International Aero Engines

SERVICE BULLETIN

ENGINE - HP COMPRESSOR - TO ANNOUNCE A NEW REAR SHAFT ASSEMBLY FOR THE
HP COMPRESSOR

72-41-00

Location of the rear shaft assembly of the HP Compressor
Figure 1

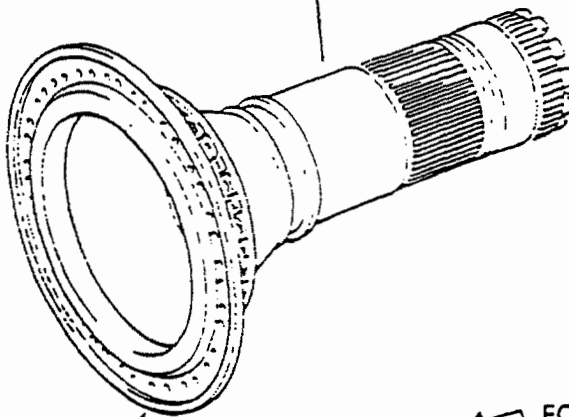
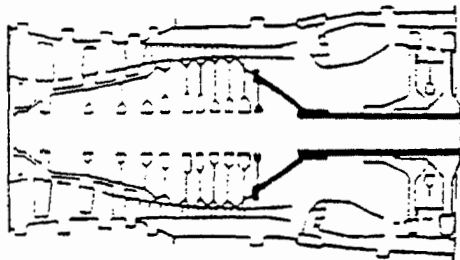
REMOVE 6A3974 OR 6A3997 SHAFT ASSY
AND INSTALL 6A4150 SHAFT ASSY
